AGENDA MANOR PLANNING AND ZONING COMMISSION 105 E. EGGLESTON ST. MANOR, TEXAS 78653 JUNE 10, 2015, 6:30 P.M.

First Construction Plan and Final Plat Review for Shadowglen Phase 2, Section 20 Subdivision City of Manor, Texas

Stonewater Subdivision Phase 5
First Final Plat Application Submittal
City of Manor

Stonewater Subdivision Phase 7 First Final Plat Application Submittal City of Manor

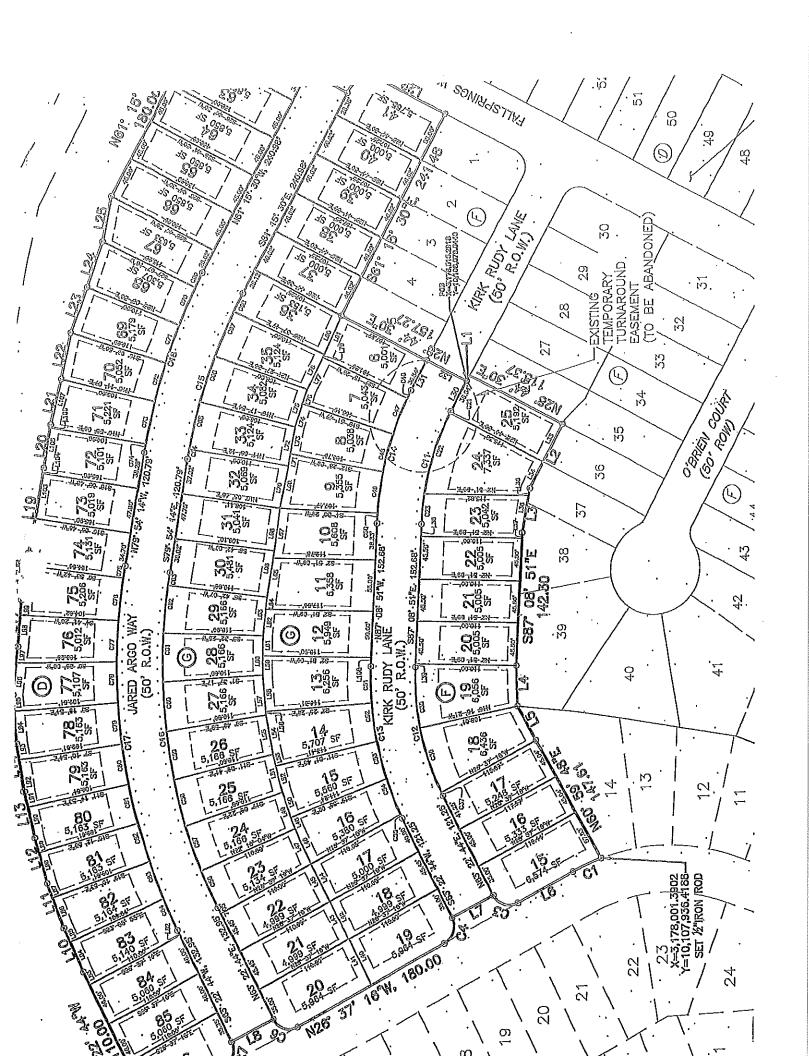
1. Provide Geotechnical Engineering Report and Pavement Design for all proposed streets and include a table or detail of proposed pavement section for each street.

2. FYI - the AARV detail should be updated to utilize the City of Manor modification or City of Austin Standard that utilizes PE pipe rather than copper tubing.

3. Include the final plat in the plans.

4. Provide benchmarks on plat and/or plans.

5. The submitted tax certificates show taxes paid for 2013 and Delinquent taxes from prior years. Tax certificates must be submitted showing all taxes paid as required in Section 24(d)(2)(v) of Subdivision Ordinance 159.

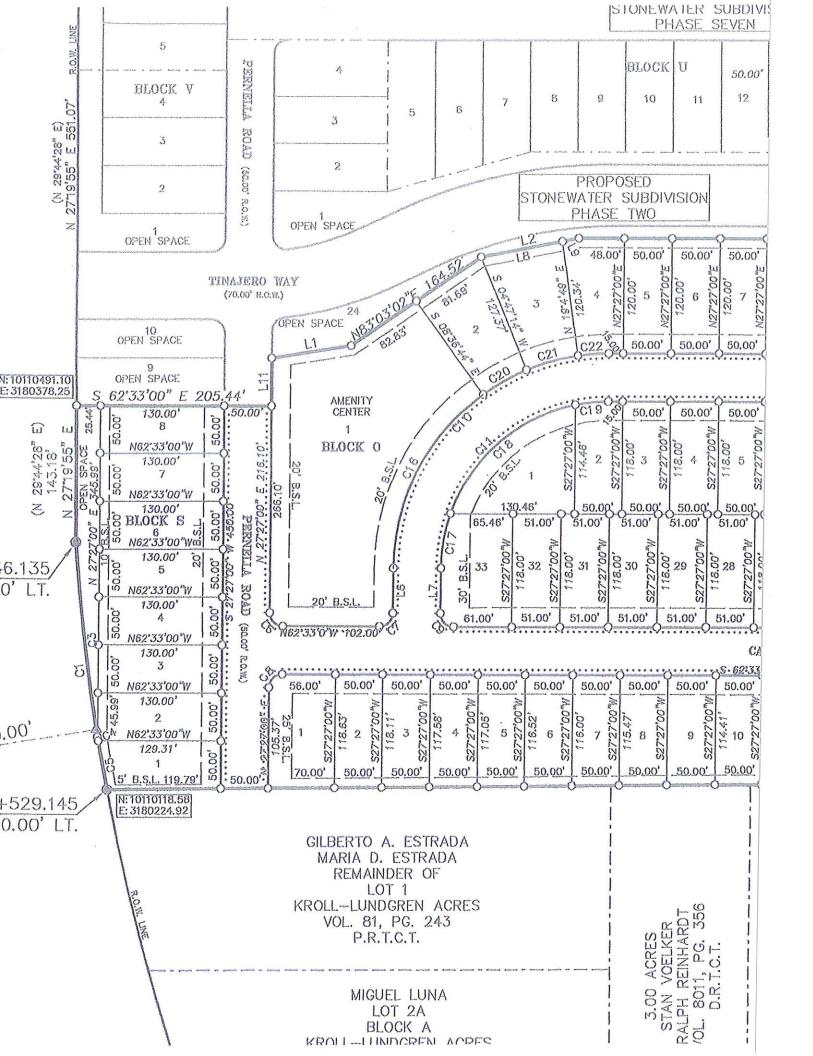
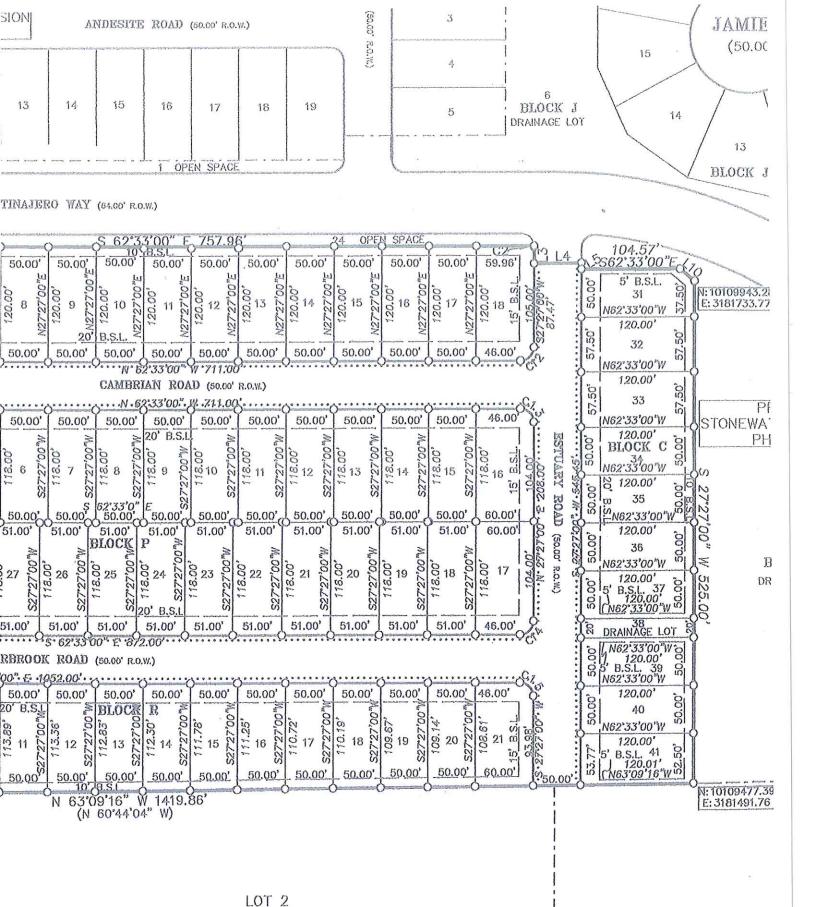
- Plat does not contain the addresses of the owner of record as required by Section 24(c)(1)(ii) of Subdivision Ordinance 263 B. The date, scale, north point, addresses of the owner of record, developer, registered public surveyor, and registered professional engineer if required, platting the tract must be shown on the plat.

- 2. The ownership of parcel 248058 needs to verified as required in Section 24(c)(1)(v) of Subdivision Ordinance 263 B. The owner's names and property lines of property within three hundred (300) feet of the subdivision boundary, together with the respective plat of deed references as determined by the most recent tax rolls must be shown on the plat.

- 5. Plat does not include the city limits line as required in Section 24(c)(2)(iv) of Subdivision Ordinance 263 B. Location of City limit lines and/or outer border of the City's extra-territorial jurisdiction, as depicted on the City's most recent base map, if either such line traverses the subdivision or is contiguous to the subdivision boundary must be shown on the plat.

- 6. The open space lot along FM973 is not numbered as required by Section 24(c)(4)(iv) of Subdivision Ordinance 263 B. The property lines and number designations of all proposed lots and blocks, with complete bearings, distances and dimensions for front, rear and side lot lines must be shown on the plat.
